New Bid Date and Time 3:00 PM, Wednesday, May 30, 2012

ADDENDUM 2

Project Name: **Hale Stadium Renovations
Tennessee State University**
Owner: **Tennessee Board of Regents**
Address: **Office of Facilities Development
Suite 664 (6th Floor, southwest) Genesco Office Park
1415 Murfreesboro Road
Nashville, TN 37217-2833**
City, State:
Project Number **SBC #166/002-02-2011
HFR# 2011171.00**
Date: **May 18, 2012**
From: **HFR Design, Inc.
7101 Executive Center Drive, Suite 300
Brentwood, TN 37027**

NOT TO SCALE

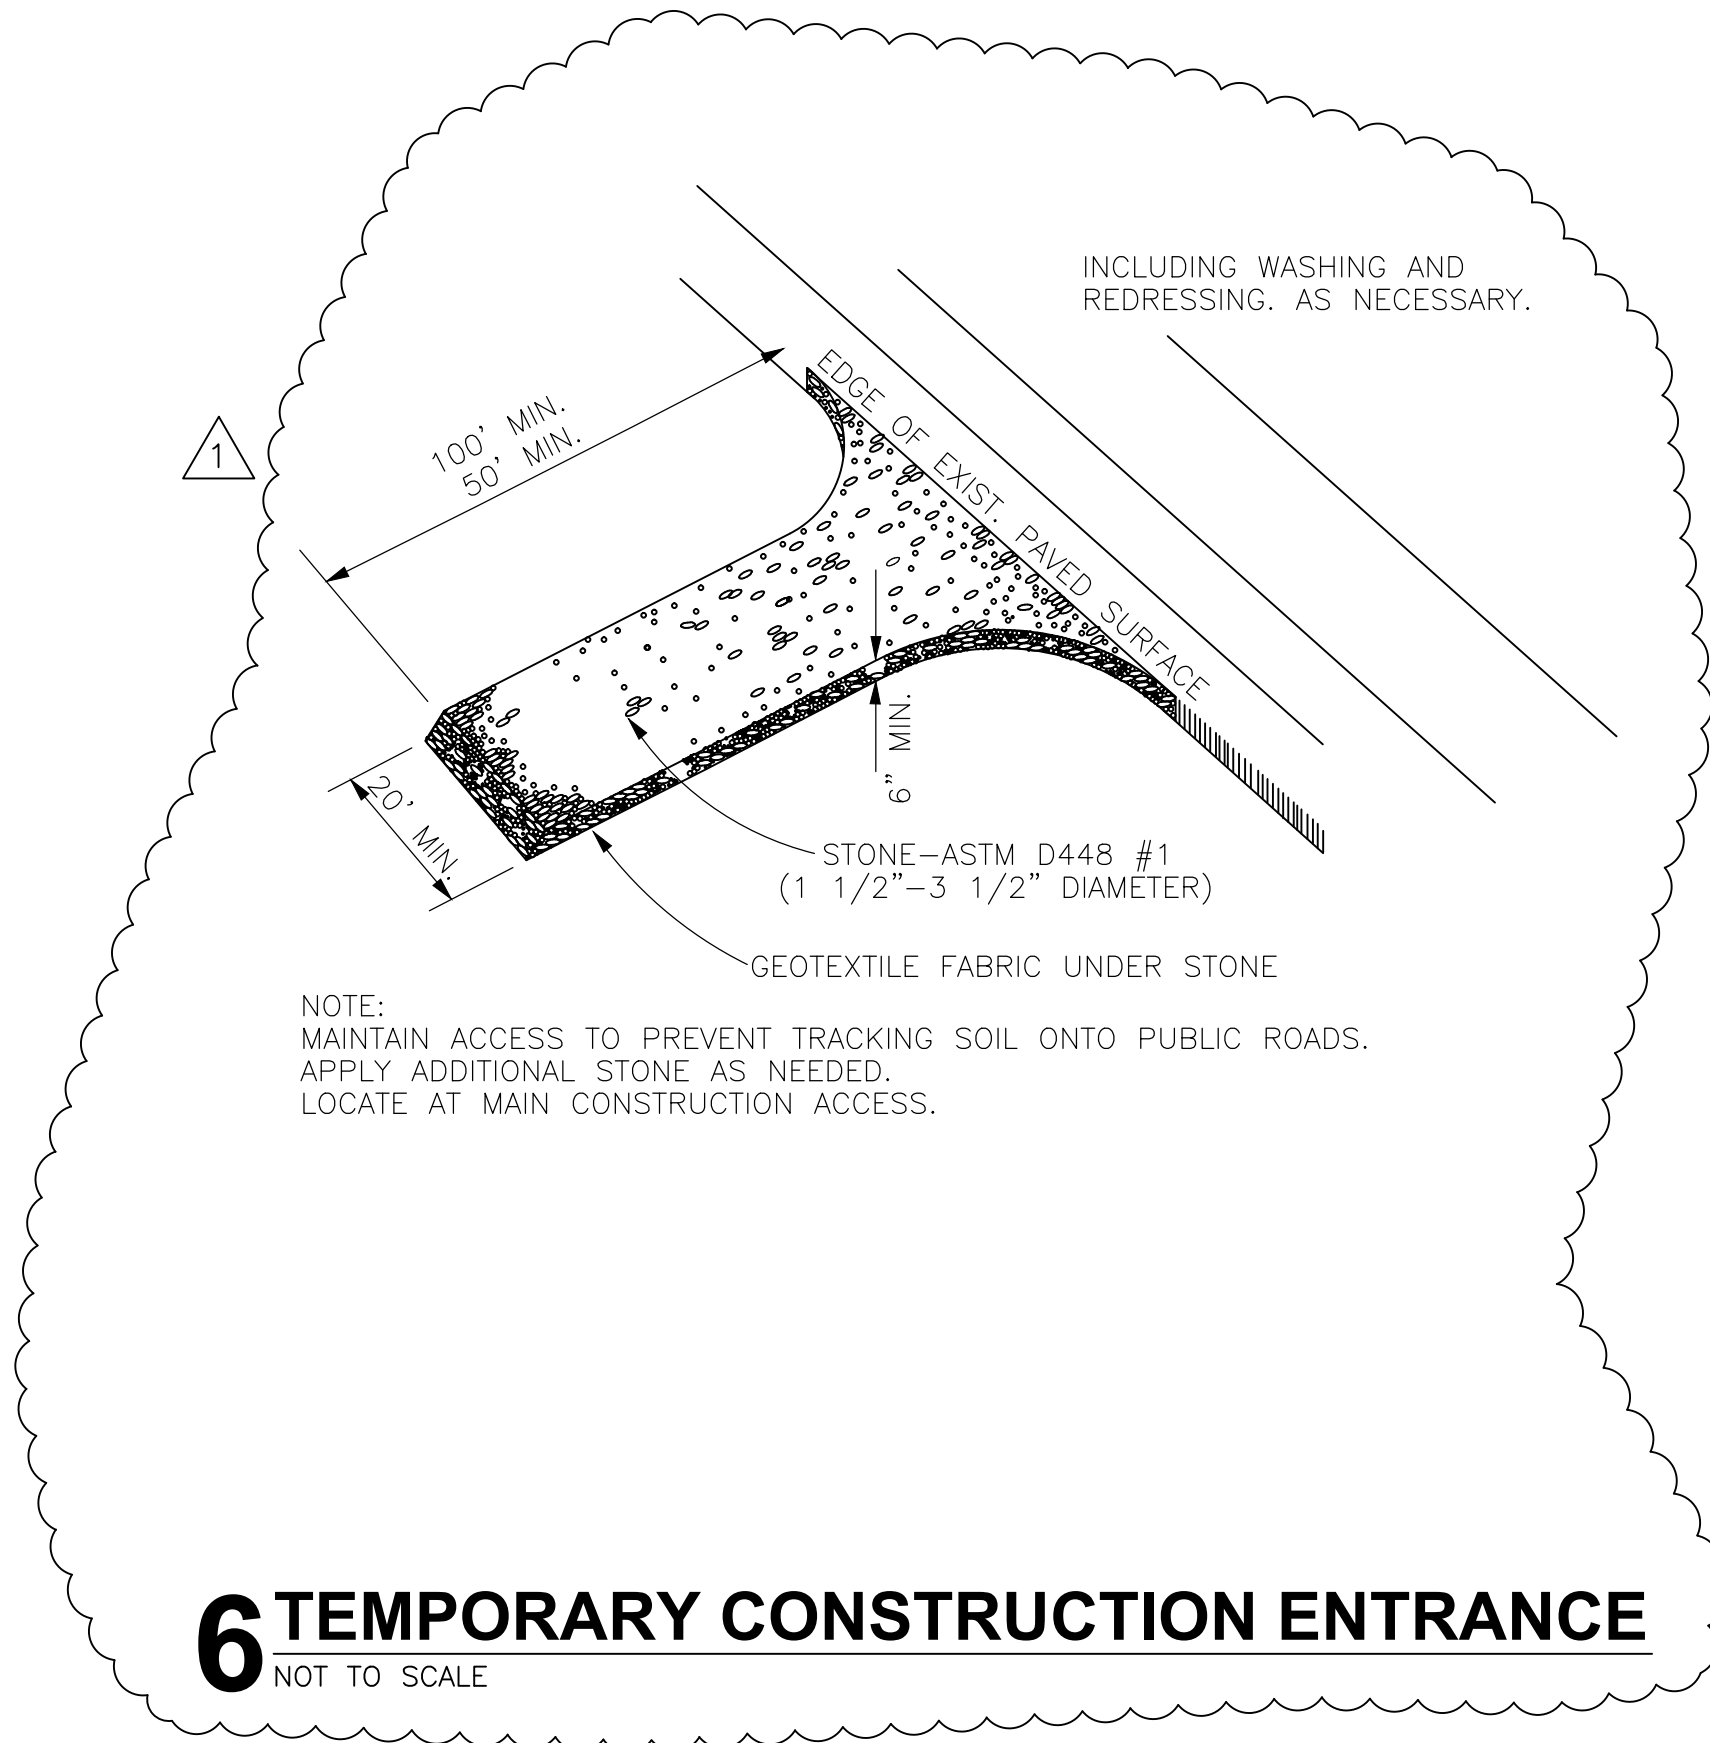
- 2-23. Drawing C4.03: Deleted detail for gate and replaced with detail for fence post with chain.
- 2-24. Drawing C4.04: Added detail for temporary construction entrance.

MECHANICAL-
FLOOR PLANS

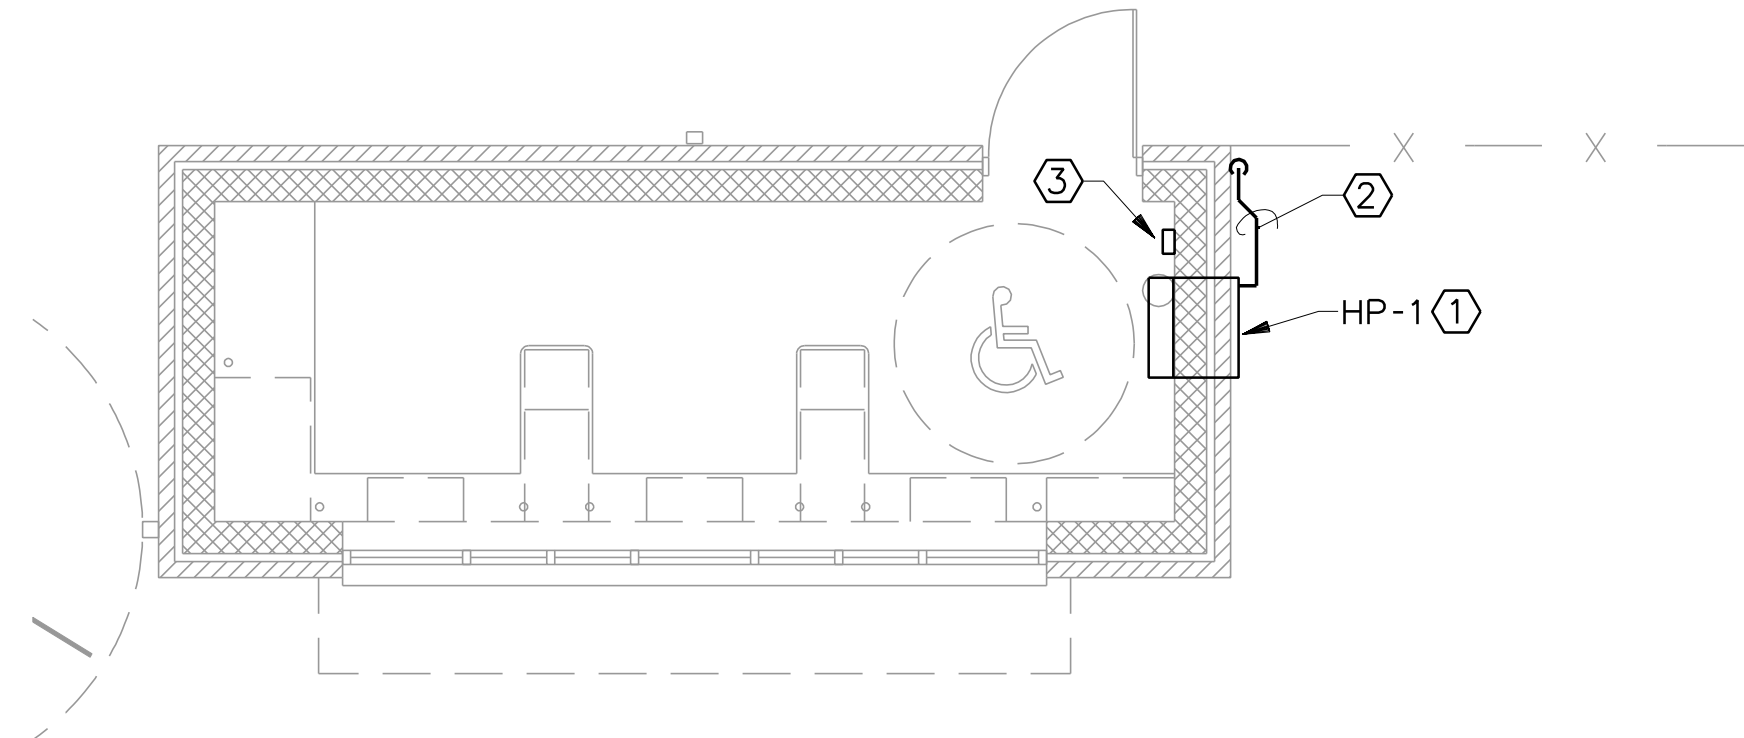
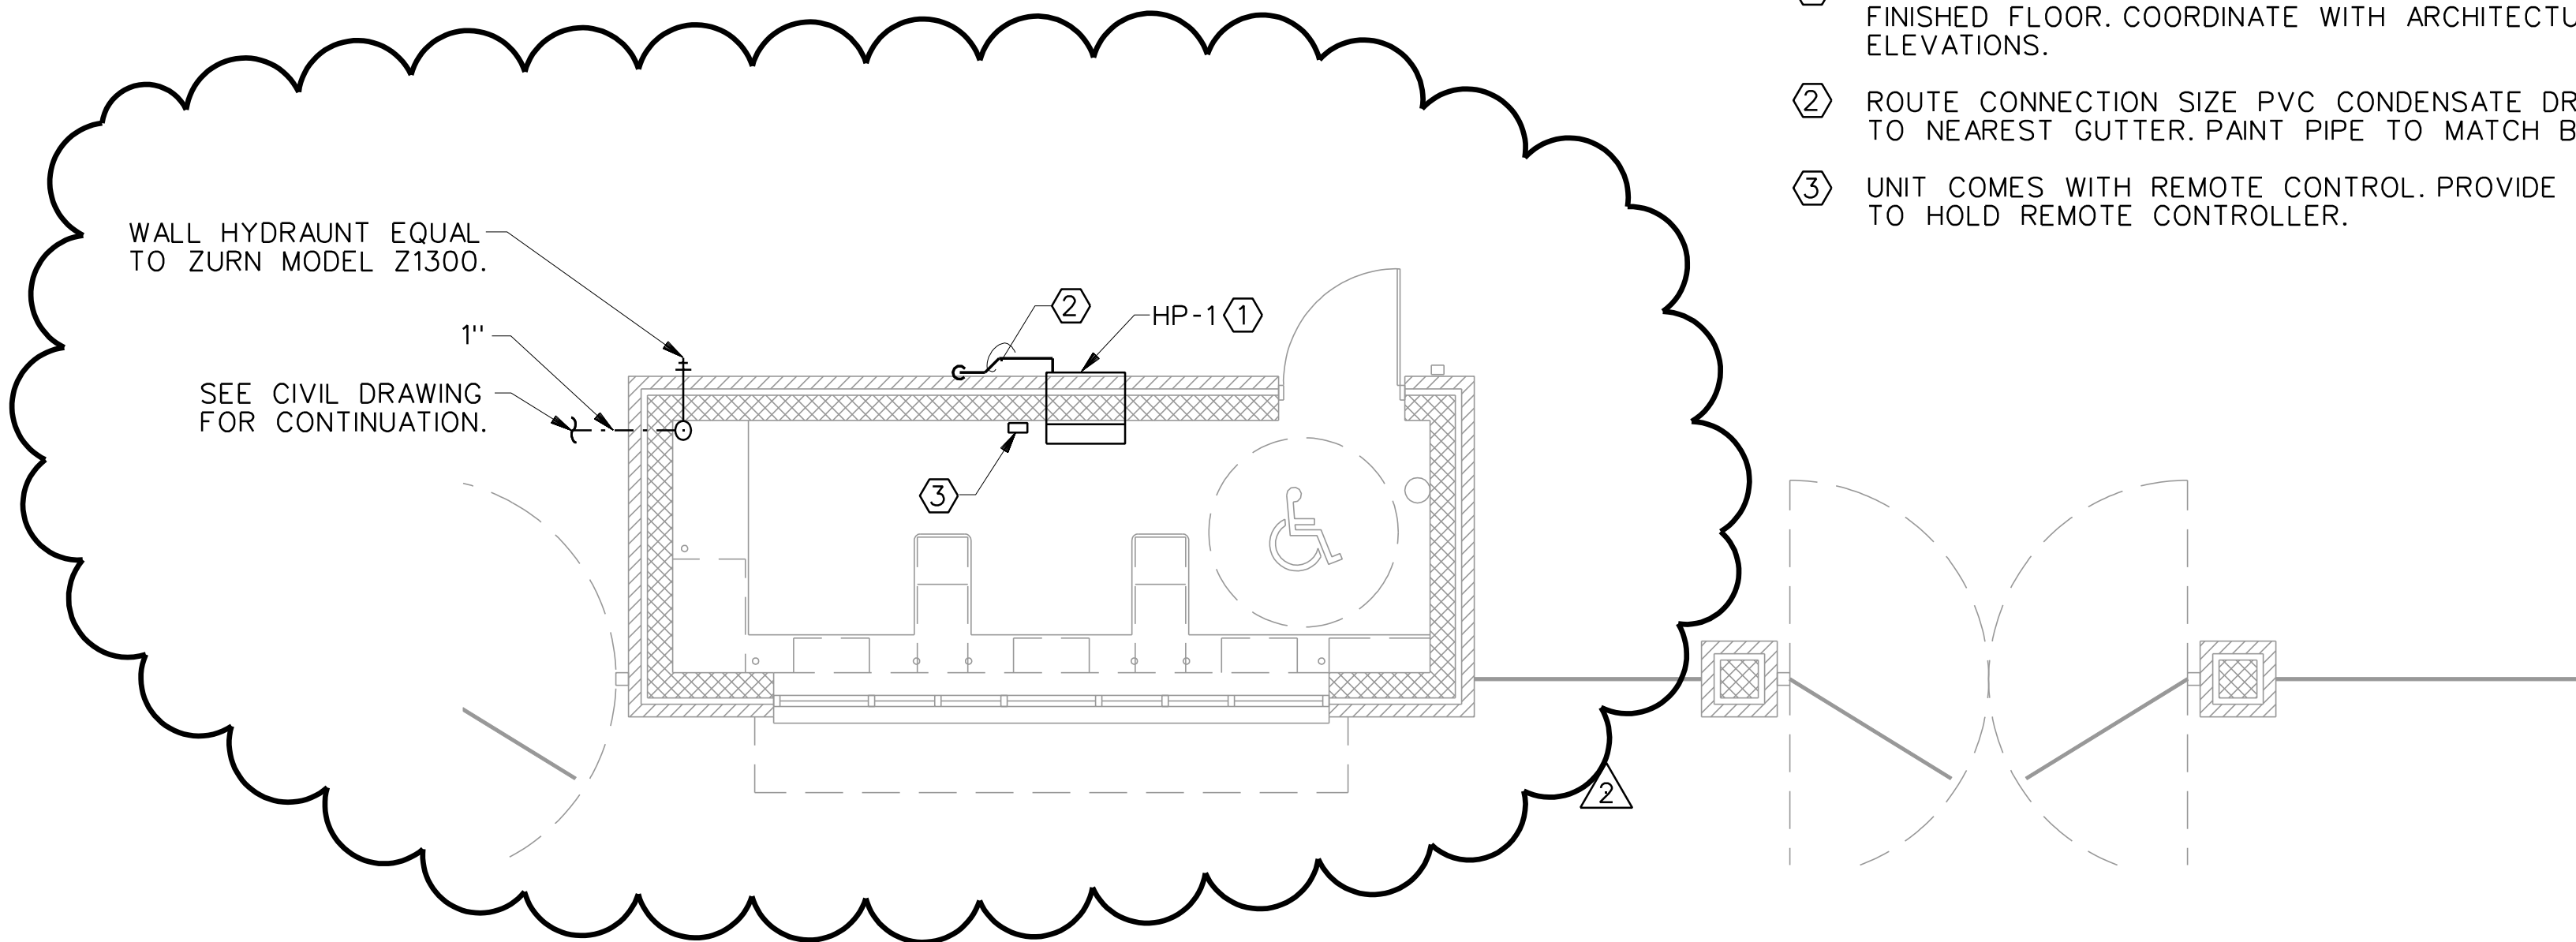
- 2-28. Drawing M1.01:
 - A. Revise location of through the wall unit per included drawing.
 - B. Add hose bib to south ticket booth.
- 2-29. Drawing E0.00: Revise all riser diagrams per included drawing.

ELECTRICAL - SITE PLAN

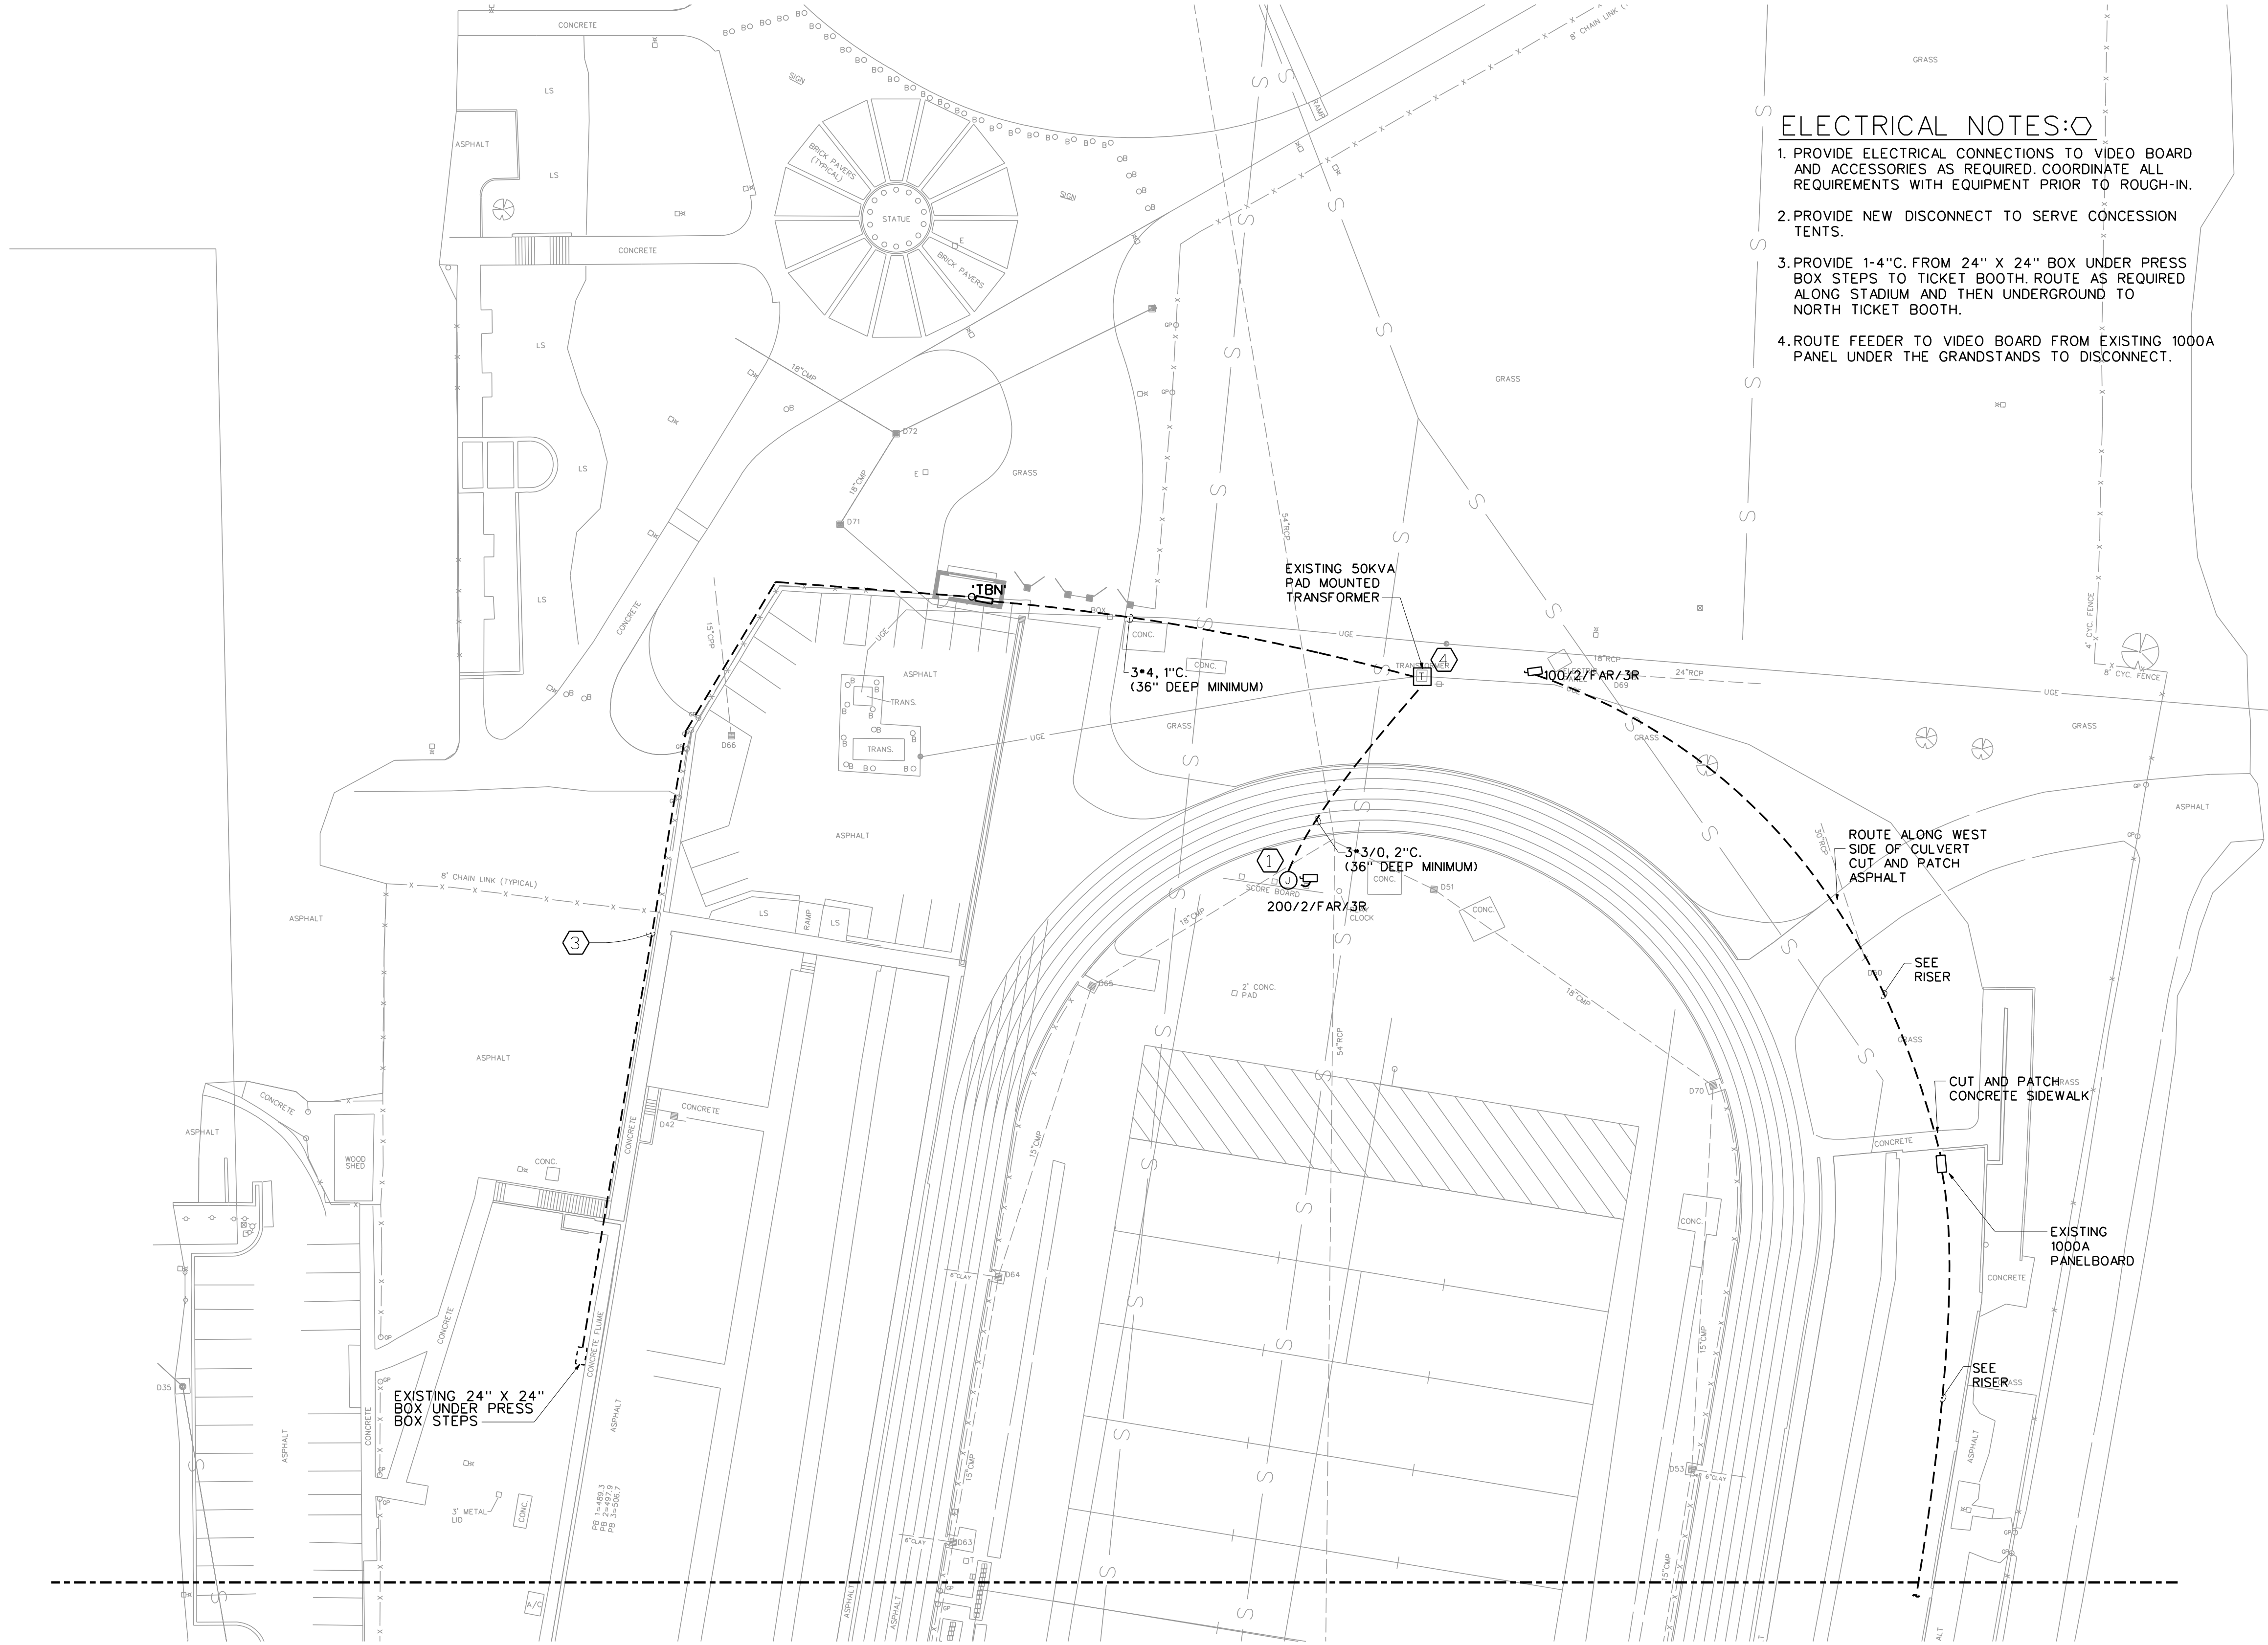
- 2-30. Drawing E0.01: Revise electrical distribution to Ticket Booth, Scoreboard, and Concession Tent and revise light pole layout per included drawing.
